ECE/TRANS/WP.29/GRSG/2008/24  
7 August 2008

**REGULATION No. 34  
(Prevention of fire risks)**

**Proposal for draft amendments to Regulation No. 34**

"Model C  
(see paragraph **3.2.4.** of this Regulation)

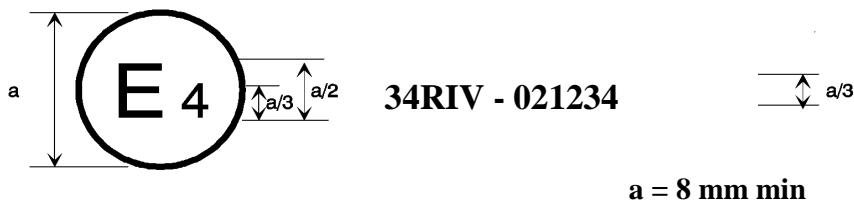
Insert new models C, D and E, to read:

**The above approval mark affixed to a fuel tank shows that the type concerned was approved in the Netherlands (E4) pursuant to Part III of Regulation No. 34, for a universal use including its accessories, under approval No. 021234. The first two digits (02) of the approval number indicate that the approval was granted in accordance with the requirements of Regulation No. 34 as amended by the 02 series of amendments.**
